Video Products Technical Bulletin 30-2003-113

SUBJECT: **PREVENTING EXCESSIVE CAPACITOR LEAKAGE CURRENT ON DA BOARD**

MODEL: **PVM-8020**
PVM-8020/5
PVM-8220
PVM-8220/5
PVM-9020ME
PVM-9020PM
PVM-9220ME

Figure 1

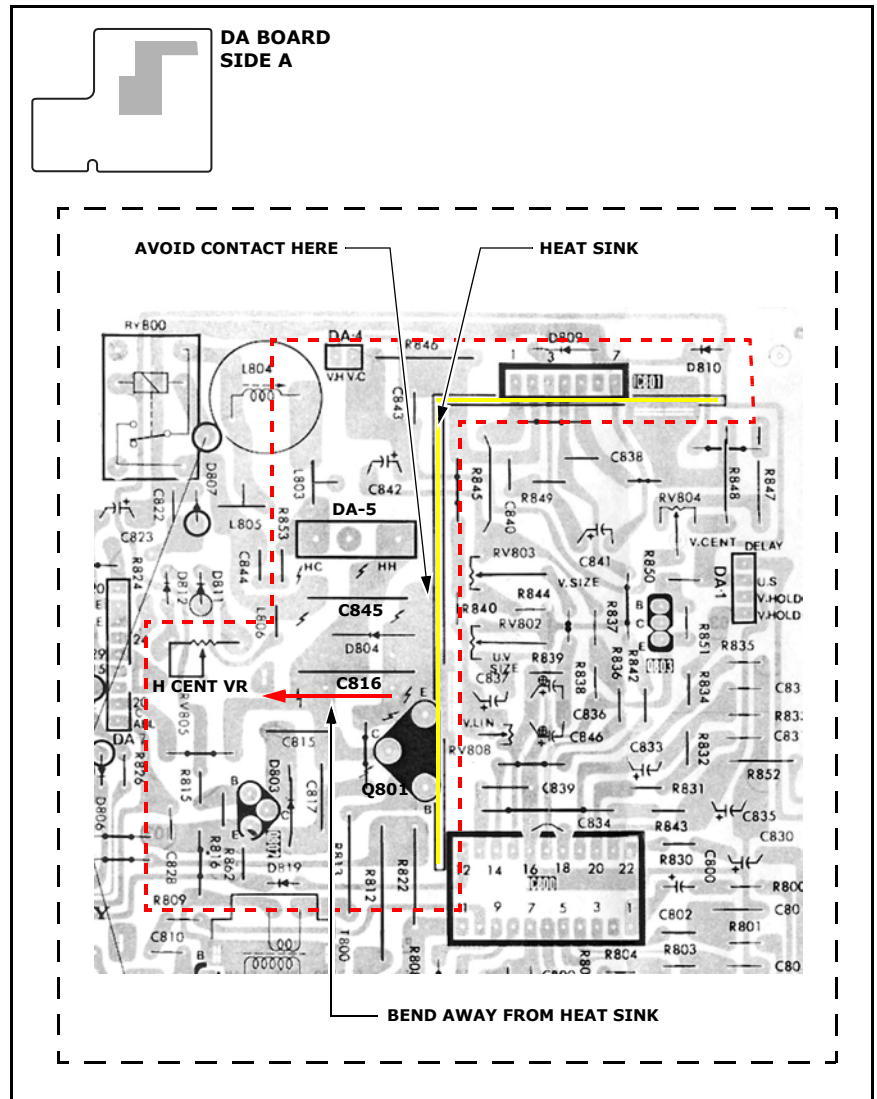
If C845 on the DA board touches the adjacent heat sink, leakage current from C845 may increase due to heat radiating from the heat sink. Excessive leakage current may damage the H CENT potentiometer.

Bend C845 and C816 away from the heat sink. (See Figure 1.)
